**U.S. DEPARTMENT OF THE NAVY
INSTALLATION RESTORATION PROGRAM**

**NAVAL AIR STATION BRUNSWICK
BRUNSWICK, MAINE**

LONG TERM MONITORING PLAN

**NEPTUNE DRIVE
DISPOSAL SITE**

ABB ABB Environmental Services, Inc. INSTALLATION RESTORATION PROGRAM NAVAL AIR STATION BRUNSWICK, MAINE	SITE LOCATION AND EXPLORATION MAP: SITE 9
	LONG-TERM MONITORING PLAN JOB NO. 7482-02 FIGURE 1-2

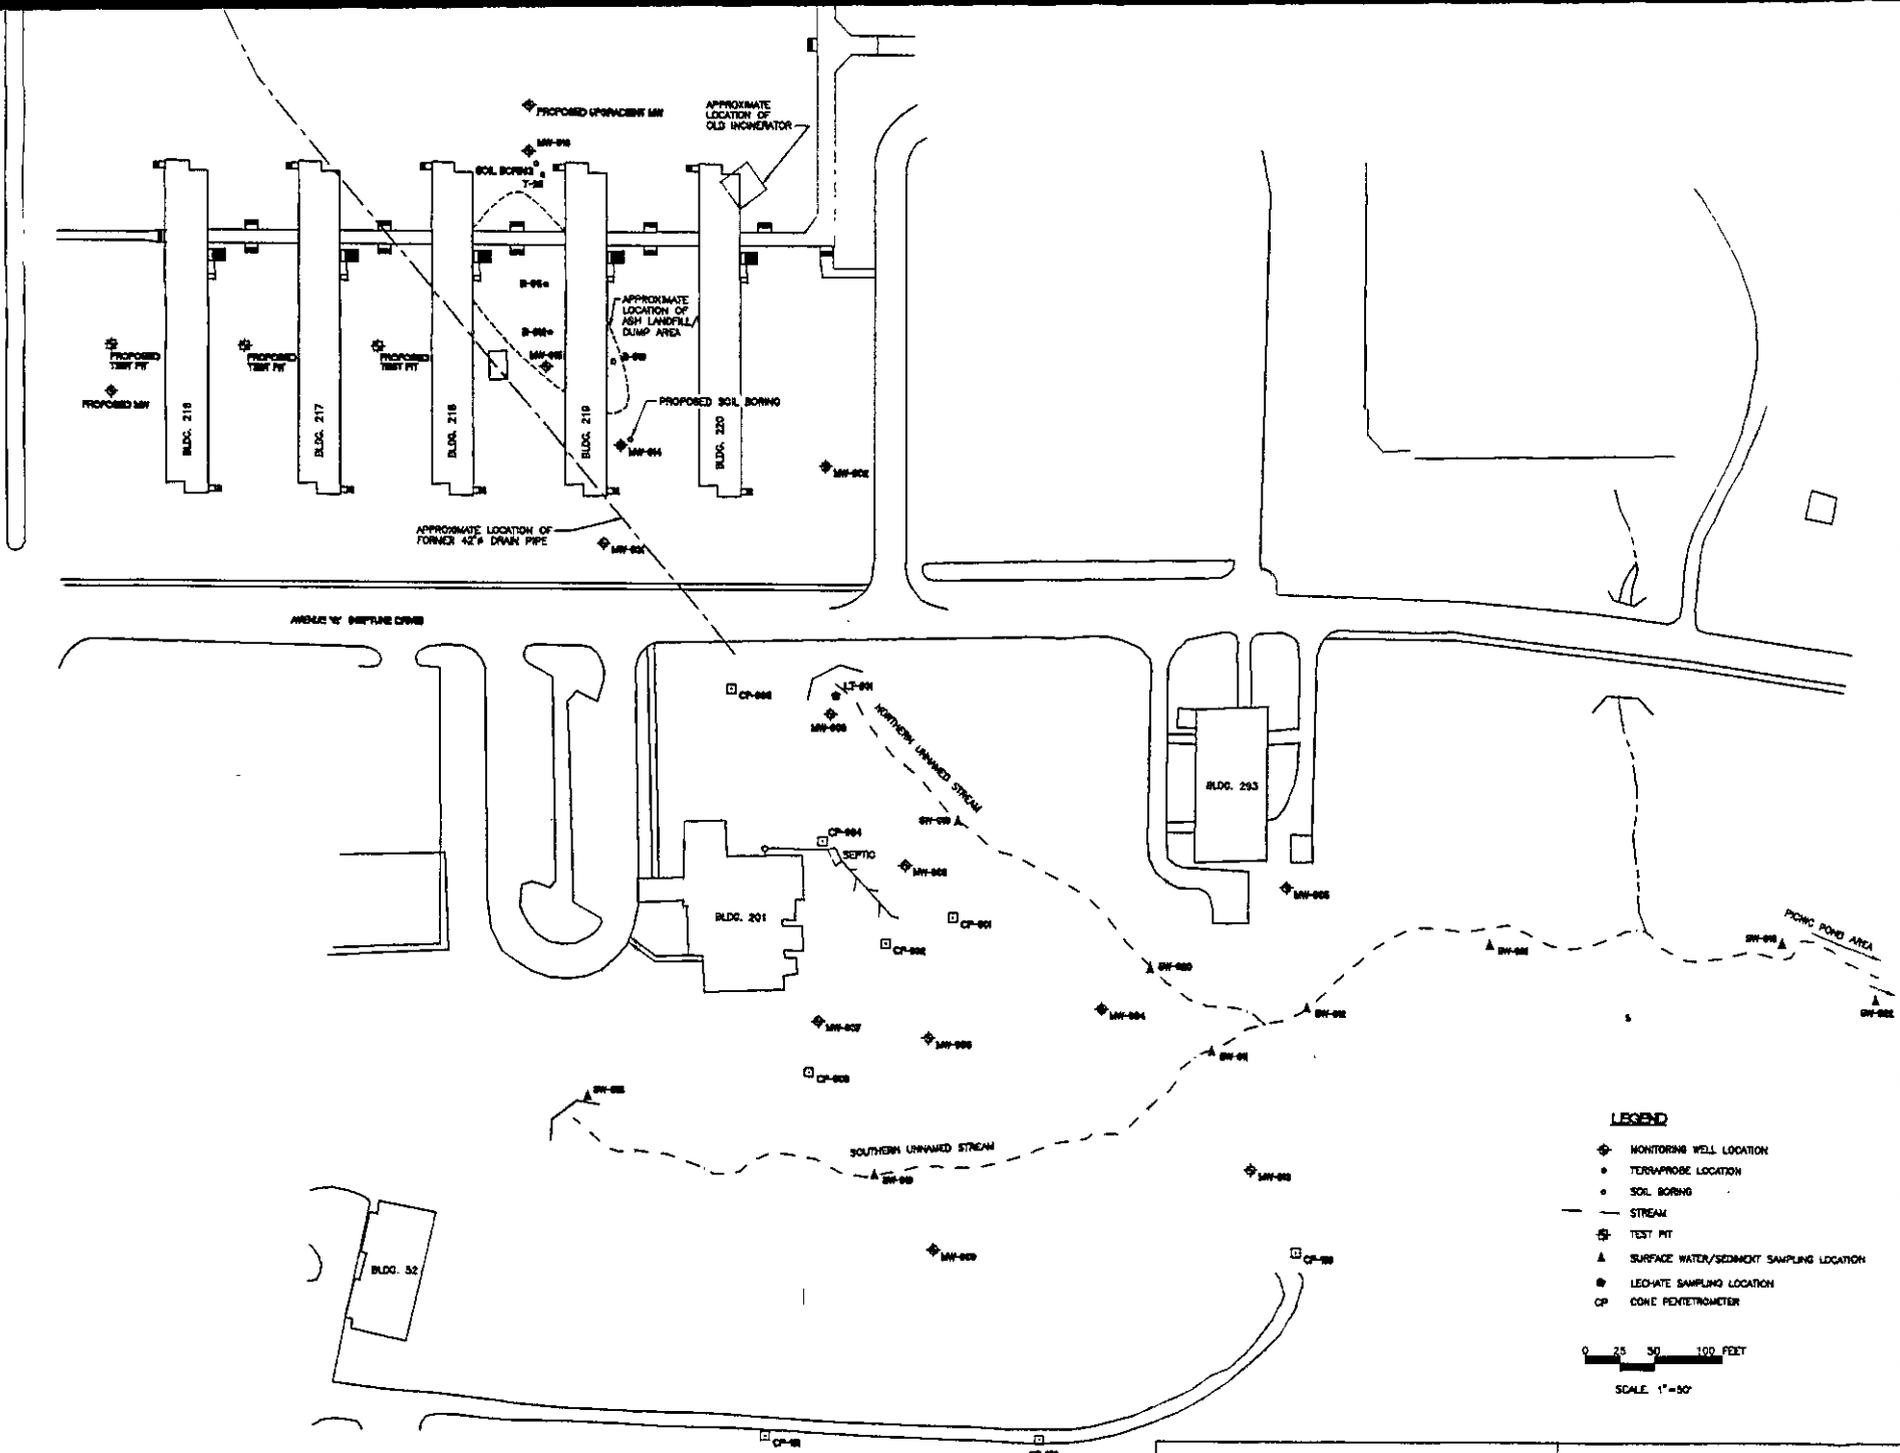
1. Page 1-4, ¶ 2, second sentence: What determines if the monitoring program is terminated? Can a termination occur before the first 5-year review?.
2. Figure 1-2: Please include a smaller scale map in addition to Figure 1-2. The smaller scale map should show and label all buildings surrounding Site 9, specifically: all buildings east of the runway, all monitoring wells associated with the PX Gas Station, all areas north of Building 52, and west of sample point SW-922.

1. Page 1-1. It is not clear where the former base landfill, described in Section 1.0 as being located north of Neptune Drive, is located. Figure 1-2 on page 1-6 shows the approximate locations of both the old incinerator and the ash disposal area (also described on page 1-1 as located north of Neptune Drive), but does not show the location of a former base landfill.

2. A smaller scale map/figure has been included that identifies the buildings in the area of Site 9 and the NEX Service Station.

Response 11: Comment noted. Figure 1-2 will be revised to indicate:

<p>ABB Environmental Services Inc. ABEA BROWN BOYER</p>	<p>AREAS OF POTENTIAL CONTAMINATION: SITE 9</p>
	<p>INSTALLATION RESTORATION PROGRAM NAVAL AIR STATION BRUNSWICK, MAINE</p>

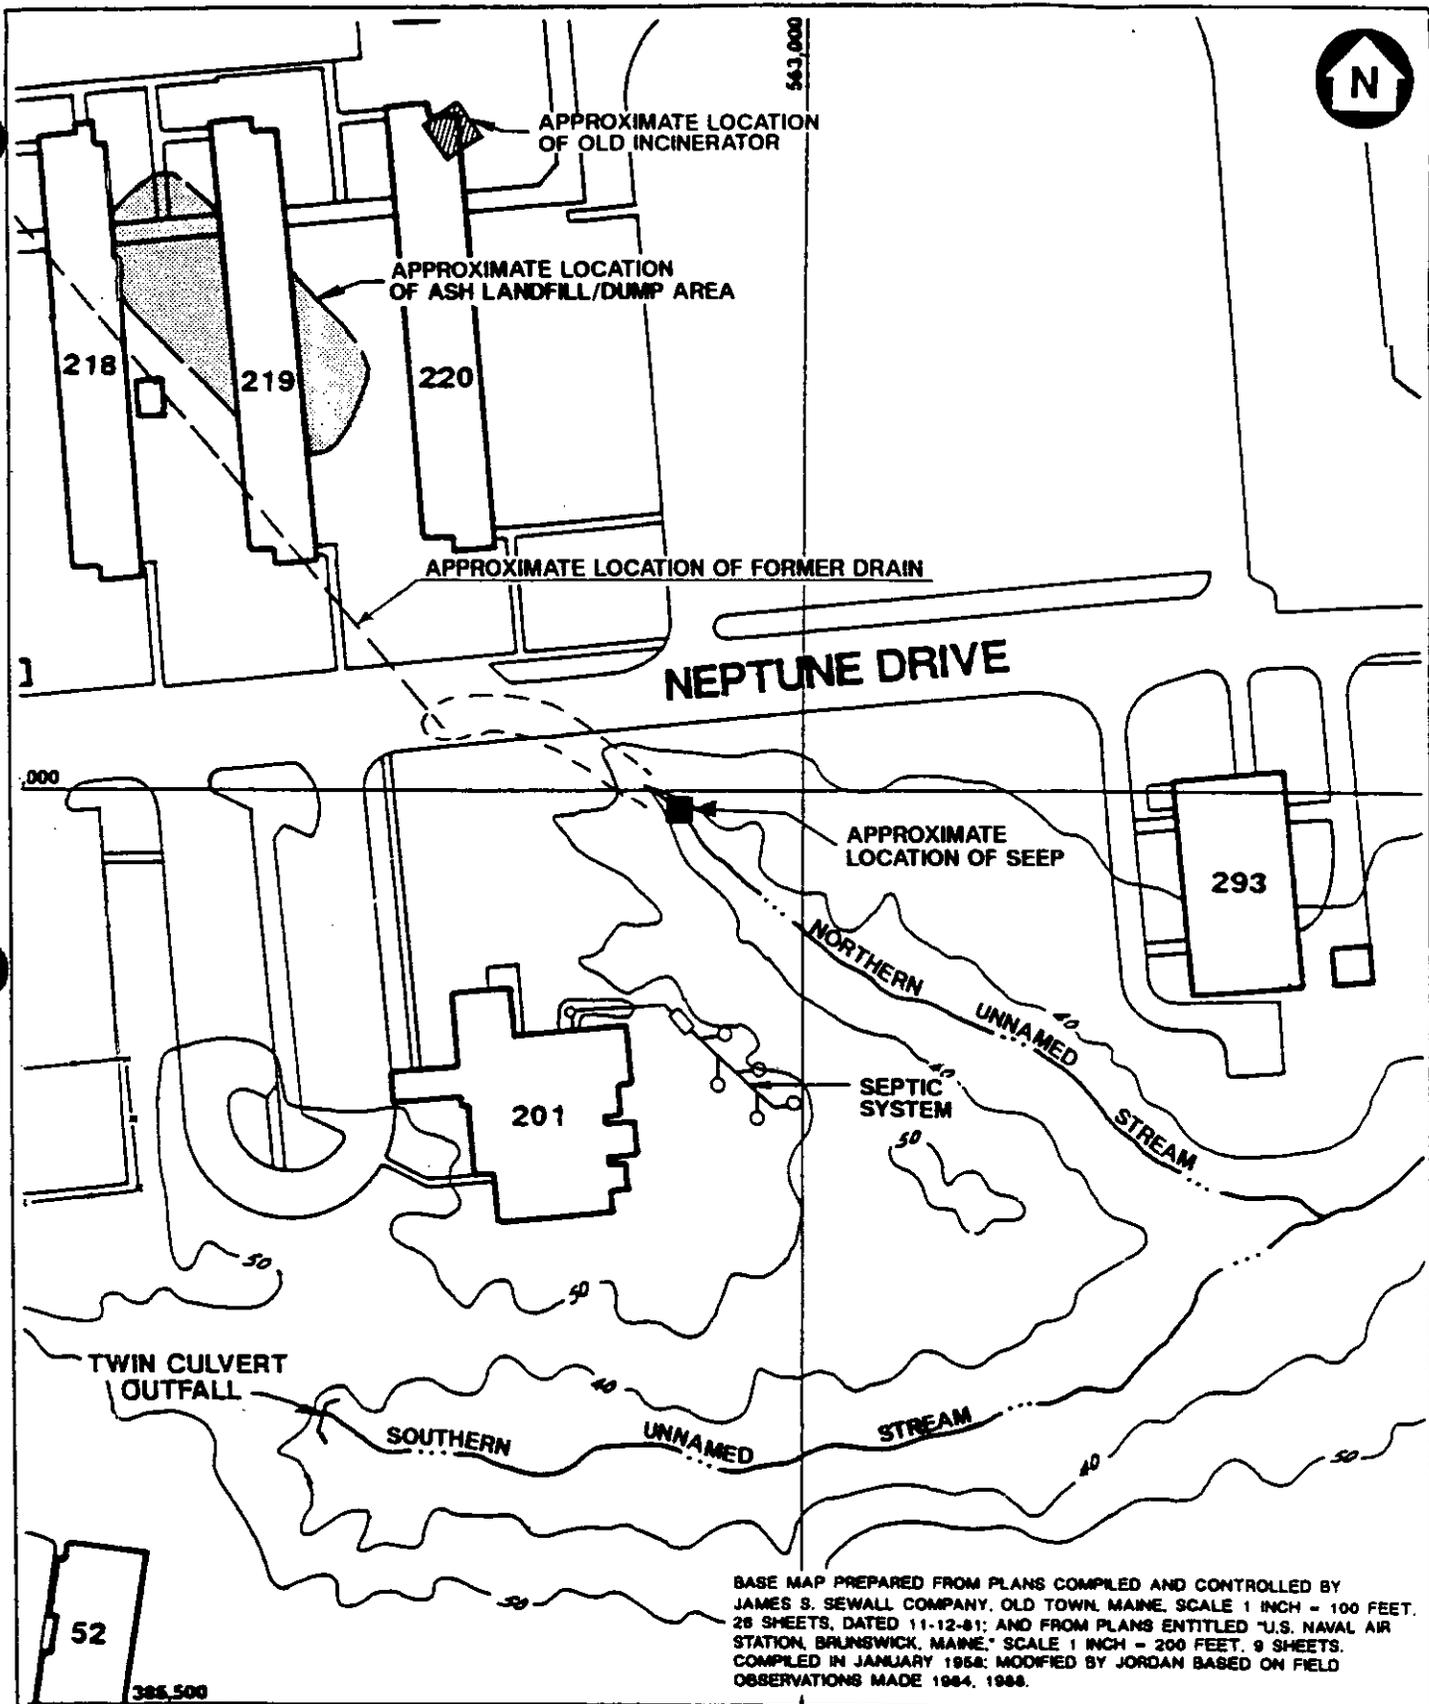
9. Figure 1-3: Figure 1-3 shows work that was completed in 1993, but those investigations are not mentioned in the text on page 1-10.
10. Page 1-17, ¶ 1, sample location SW-915: The Navy should consider sample location SW-915 as an on-site sampling location. Seasonal groundwater directions are unknown. Groundwater from Site 9 may be discharging at SW-915.

ABB Environmental Services, Inc.	GROUNDWATER CONTOURS AND MONITORING WELL LOCATIONS
	LONG TERM MONITORING PLAN
INSTALLATION RESTORATION PROGRAM NAVAL AIR STATION BRUNSWICK, MAINE	JOB NO. 7482-02 FIGURE I-4

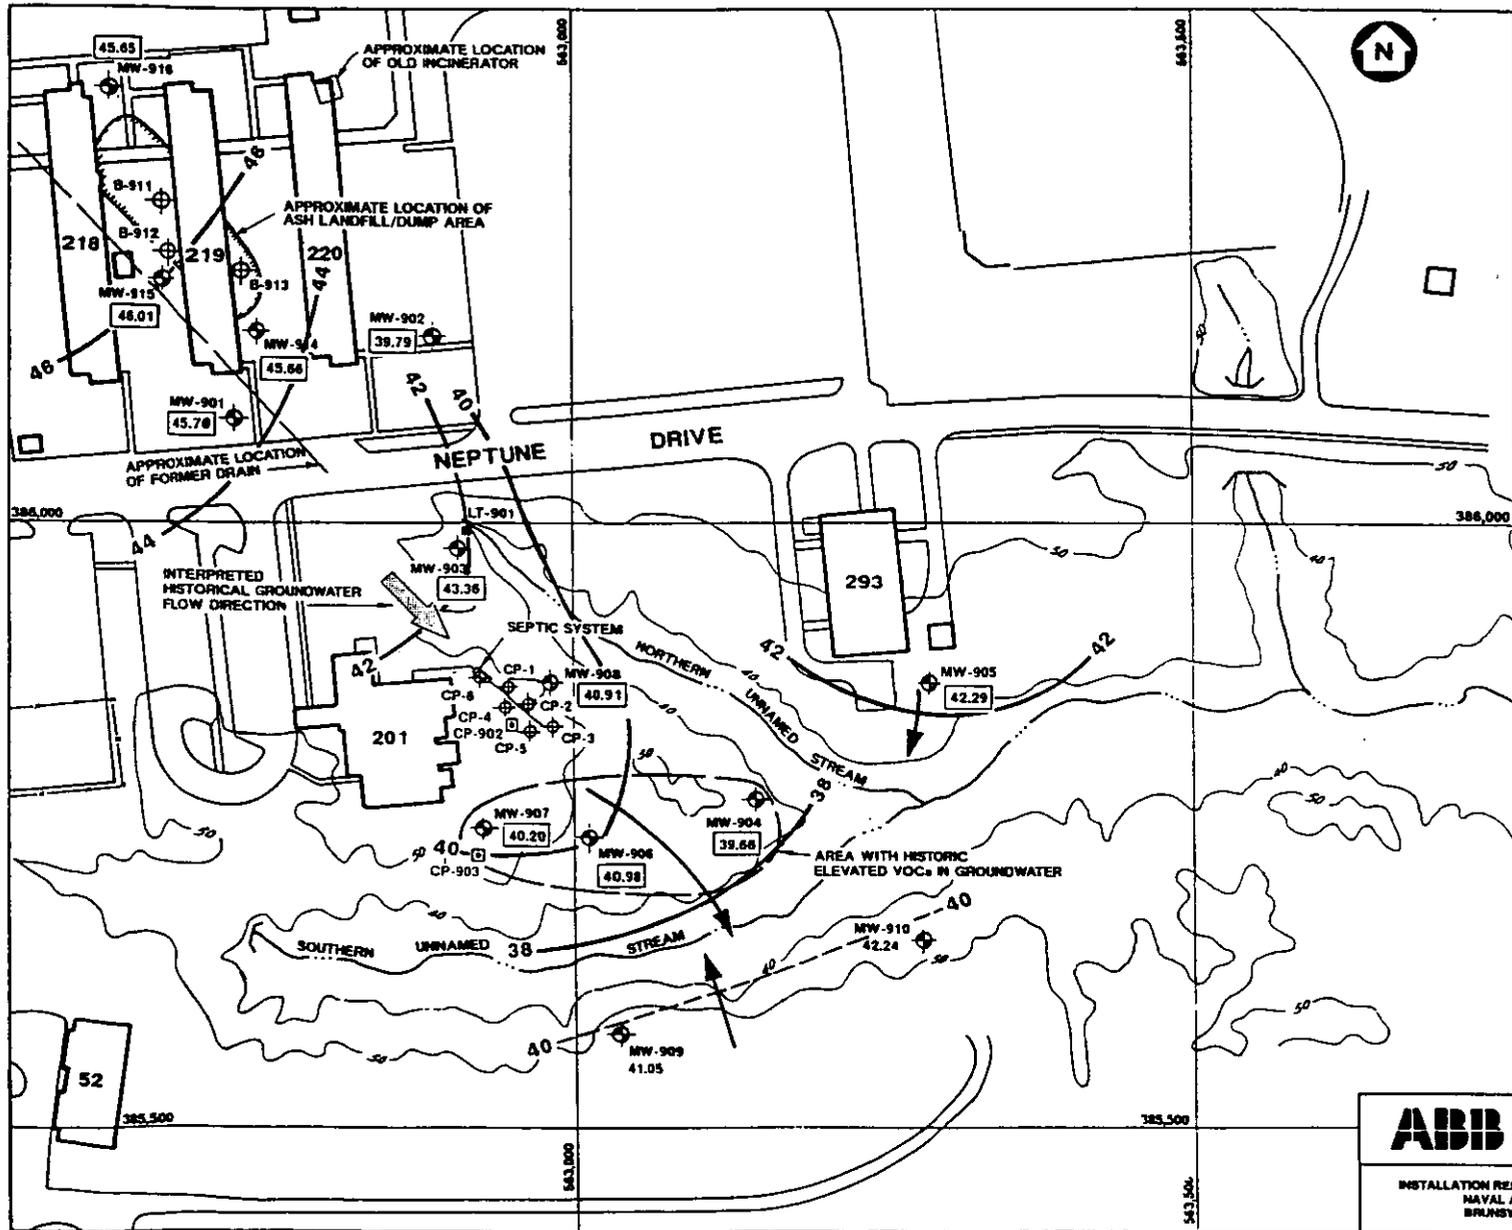
3. Page 1-15. The "area with historic elevated VOCs in groundwater" drawn on Figure 1-4 does not reflect that volatile organic compounds (VOCs) have been detected in CP-902 and MW-908.

3. Figure 1-4 has been revised to show that VOCs have been detected at CP-902 and MW-908. CP-902 was not a monitoring well and therefore not shown as a historic monitoring point. MW-908 has shown no consistent presence of VOC contamination. Figure 1-4 has been presented in previous documents which have been accepted by USEPA and MEDEP. The purpose of this figure is to show interpretive groundwater surface contours. The additional information provided by labeling the locations of past VOC detections was provided for reference only.

<p>ABB Environmental Services, Inc. ASEA BROWN BOVERI</p>	<p>PAH CONCENTRATIONS IN SURFACE SOILS (0'-2') SITE 9</p>	
	<p>LONG-TERM MONITORING PLAN</p>	
<p>INSTALLATION RESTORATION PROGRAM NAVAL AIR STATION BRUNSWICK, MAINE</p>	<p>JOB NO. 7131-00</p>	<p>FIGURE 1-5</p>

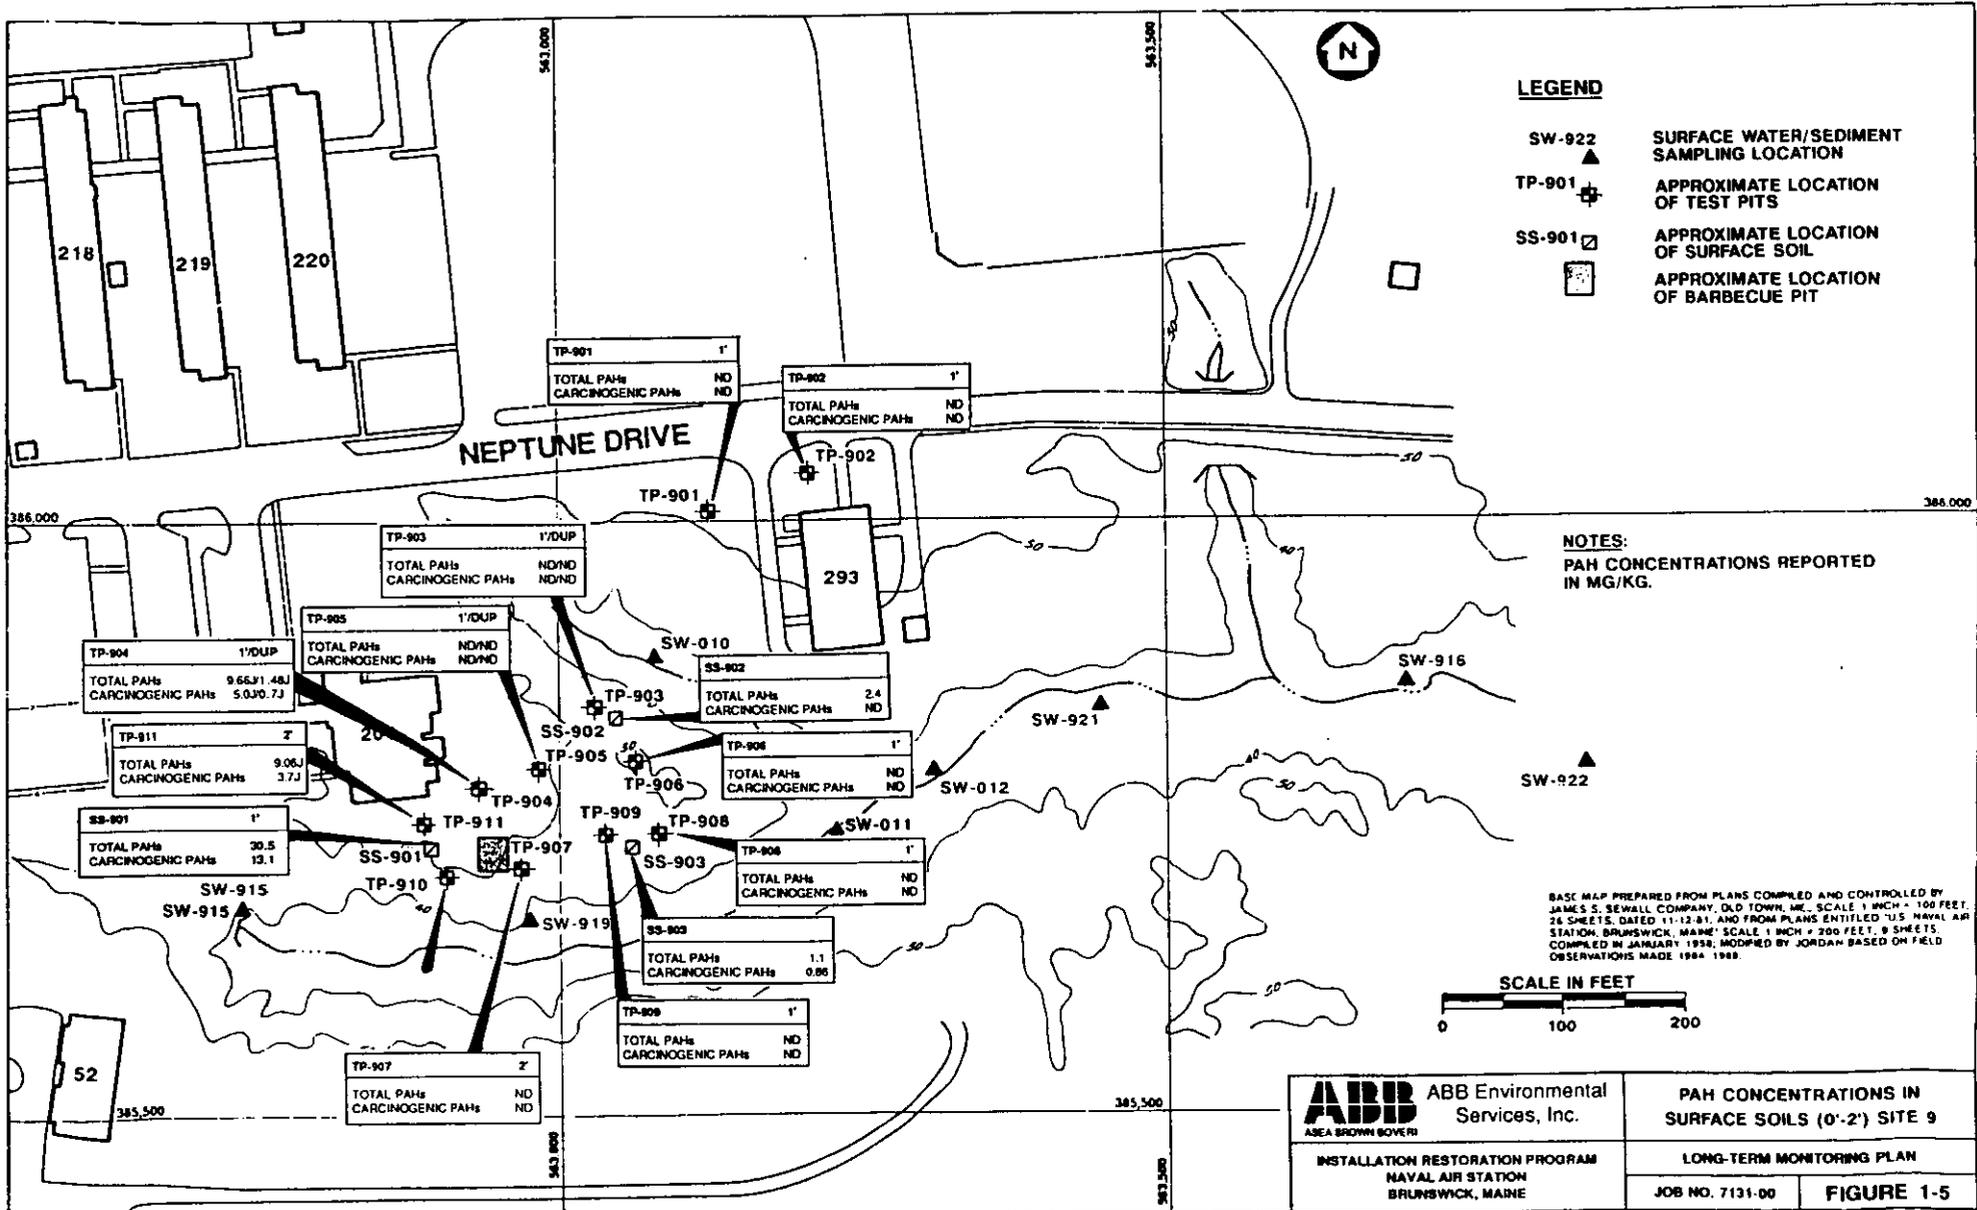
1. Page 1-9: A brief description of the current/recent use of Building 201 and the area behind it should be provided.
2. Page 1-15, Figure 1-5: There is no mention in the text of dibenzofuran reported at 5,100 ug/Kg in the sediment at SD-011.
3. Page 1-16, ¶ 2: Provide discussion on SW-916 where toluene was detected at a higher level than SW-915 (i.e., to what can this be attributable?).
4. Page 1-16, ¶ 2: Specify whether compounds identified for surface water samples exceeded acute or chronic AWQC.

1. A brief description of the current use of Building 201 has been added to the text.
2. Text has been added stating that dibenzofuran was detected at SD-11 at a concentrations of 5.1 mg/kg.
